Planning Commission Staff Report

Project Type: Sign Package

Description: **Kraus Farm Office Center (OPUS I & II), Sign Package:** A request for a Sign Package to establish sign criteria for the Kraus Farm Office Center development located on the north side of North Outer 40 Road, west of Timberlake Manor Parkway.

Sign Package Submittal

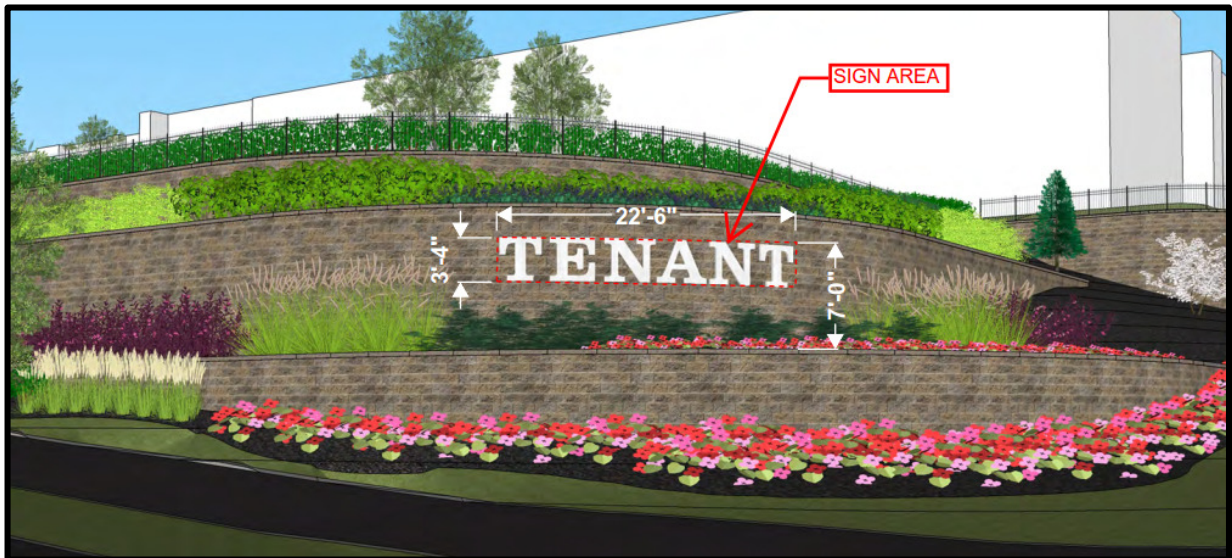
As this site has frontages on three (3) roadways, per the UDC three (3), fifty (50) square feet, freestanding (monument) signs would be permitted. However as seen in the Sign Package proposal, the request is for one (1) monument sign of 75 square foot for the development. The proposed metal channel letters for this sign will be pin mounted on the retaining wall near the southern entrance for the site, as seen in the image below. This sign will be ground lit by three (3) LED fixtures. These fixtures will be fully shielding, low voltage fixtures and will be angled towards the sign, minimizing excessive lighting, glare and light trespass onto adjoining properties. The exact fixture type will be reviewed with the Municipal Zoning Approval (MZA) application for the sign.

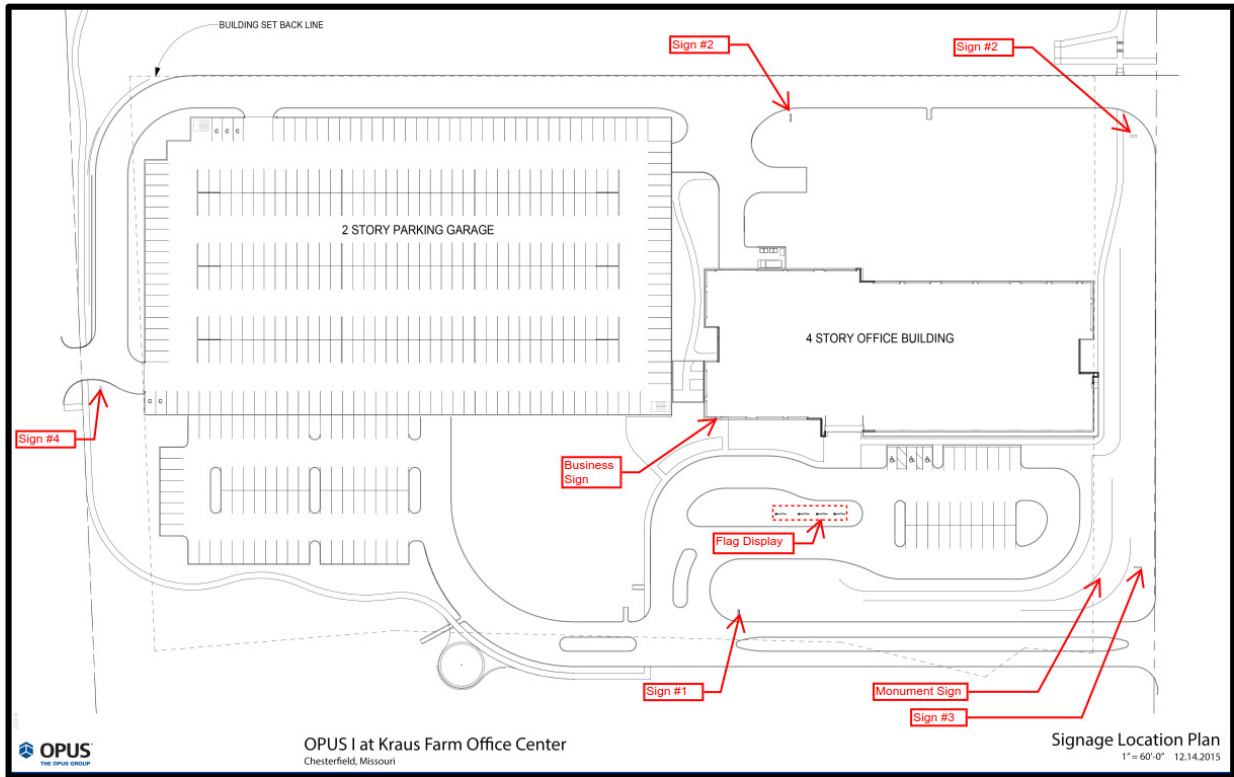
The image below shows the proposed location of the all the signs, including monument sign, on the site.

**BUILDING SIGNAGE
DETAIL**

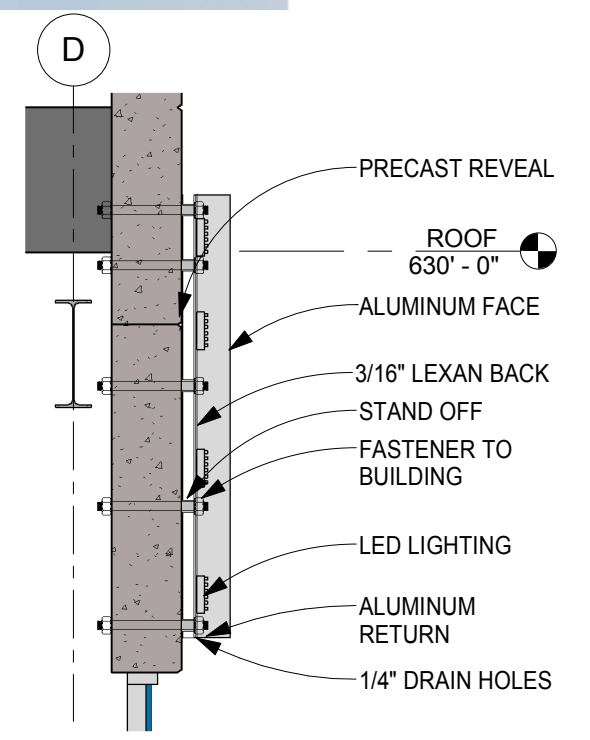
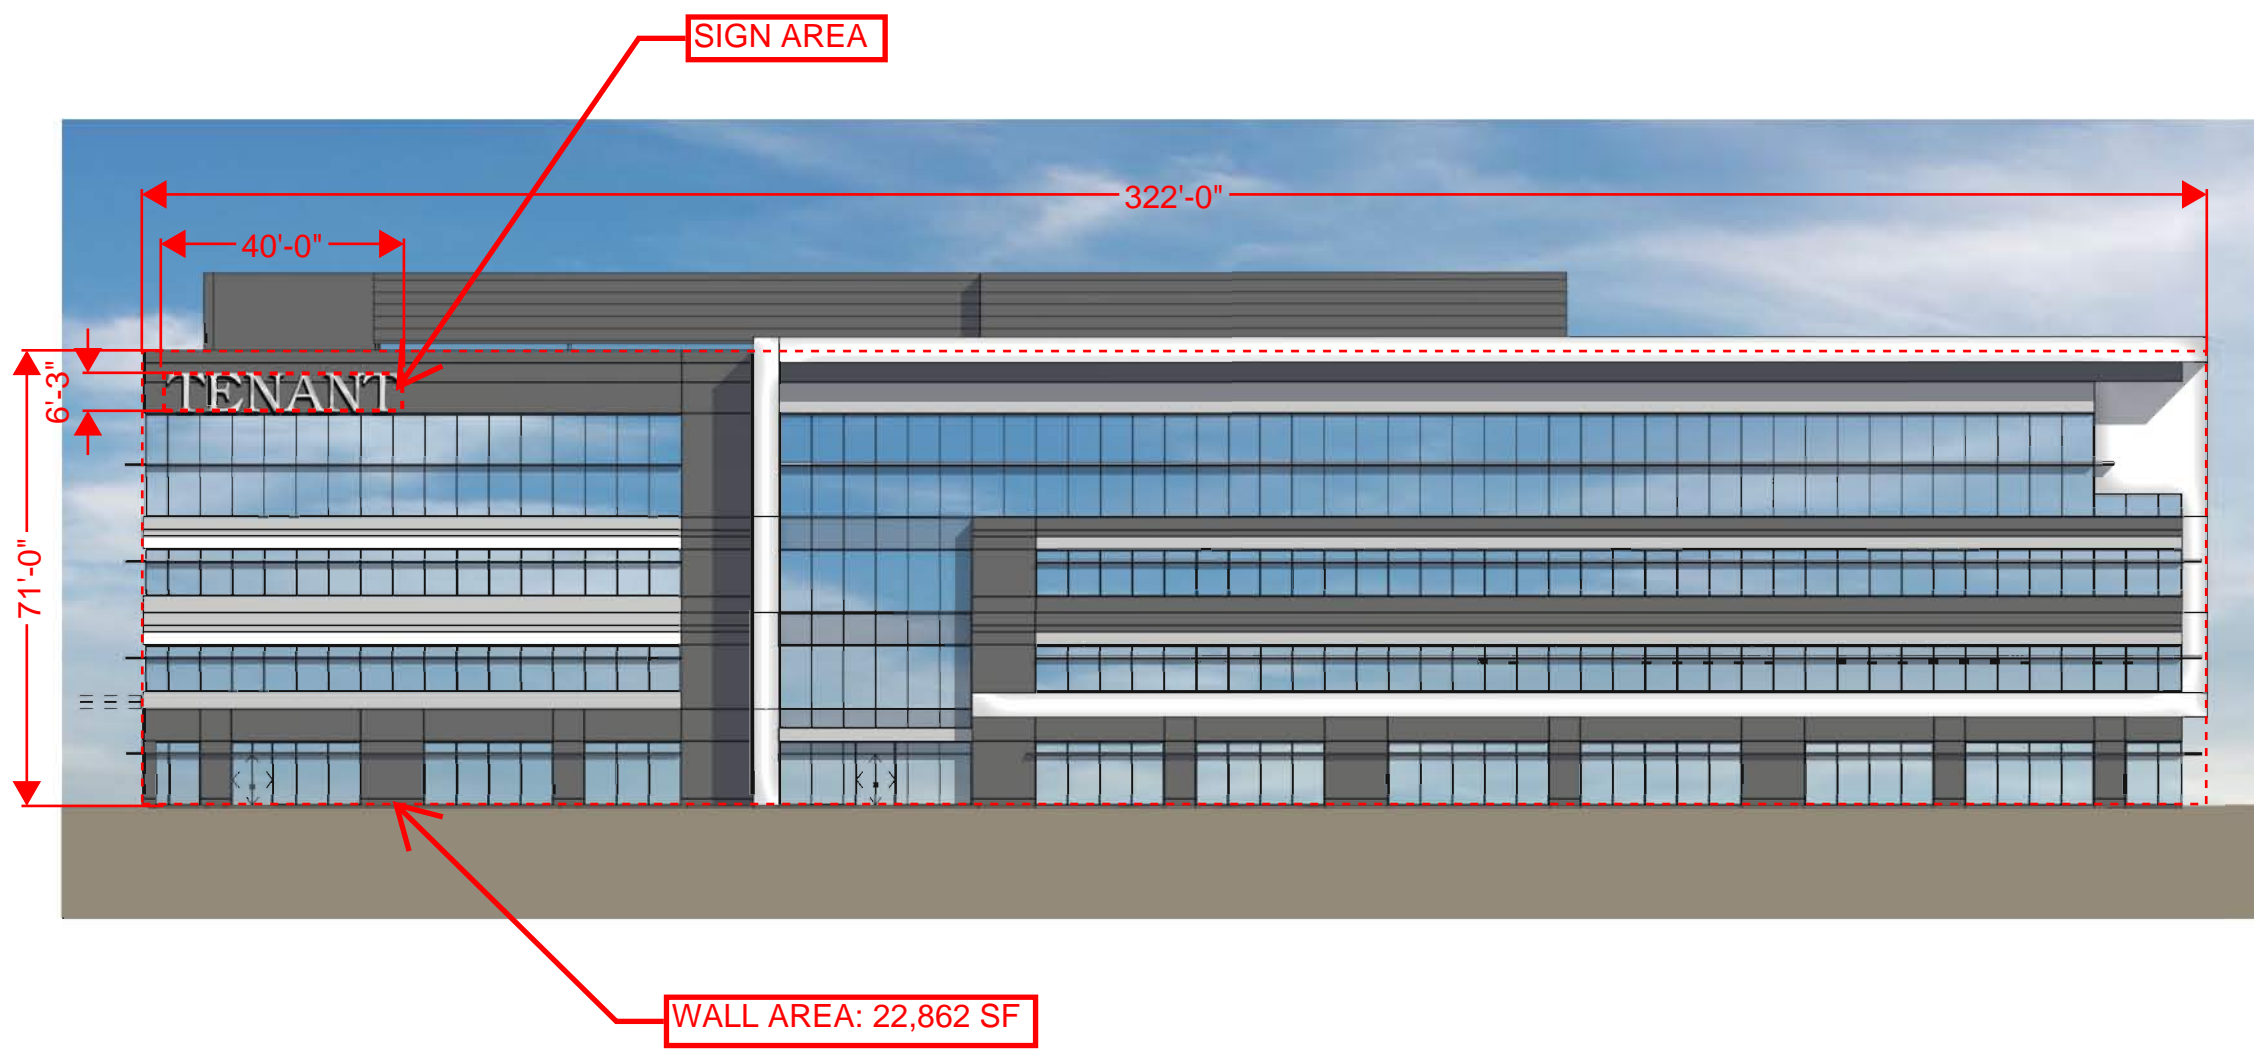
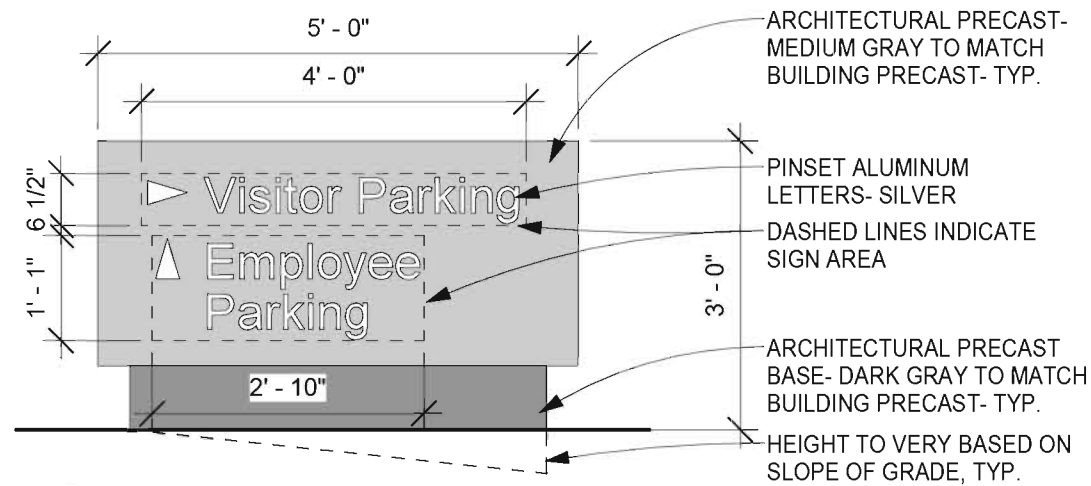
The applicant is only requesting one, 250 square foot, attached wall sign for the development. This metal channel letter sign will be pin-mounted, with LED backlighting on the southern façade of the building. The proposed attached wall sign is approximately 1% of the southern façade of the building. The proposed sign and installation detail are provided below. **Per the UDC, this site would be permitted three (3) attached wall signs; however, the applicant is only requesting one (1) attached wall sign.**
